# MPC7457 Hardware Specification Addendum for the MPC74*n*7RX*nnnn*N*x* Series

This document describes part-number-specific changes to recommended operating conditions and revised electrical specifications, as applicable, from those described in the general *MPC7457 RISC Microprocessor Hardware Specifications* (Order No. MPC7457EC). The MPC7457 and MPC7447 are implementations of the PowerPC™ microprocessor family of reduced instruction set computer (RISC) microprocessors.

Specifications provided in this document supersede those in the *MPC7457 RISC Microprocessor Hardware Specifications*, Rev. 5 or later, for the part numbers listed in Table A only. Specifications not addressed herein are unchanged. Because this document is frequently updated, refer to http://www.freescale.com or to your Freescale sales office for the latest version.

**Figure 29. Freescale Part Marking for BGA Devices**

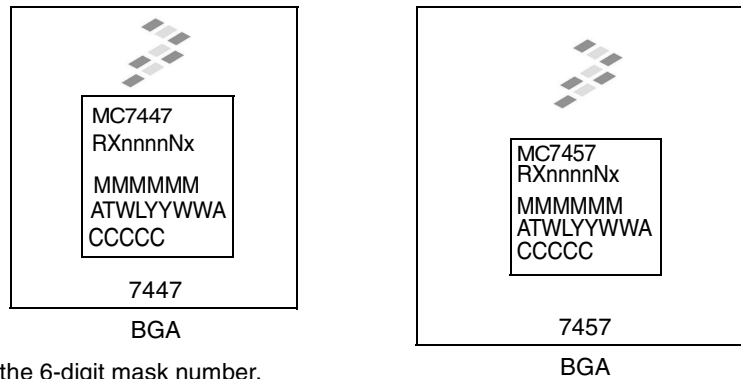
| Rev. No. | Date | Substantive Change(s) |
|---|---|---|
| | | Corrected typo in Figure 29: 7447 device was incorrectly marked...RX10000NB. |
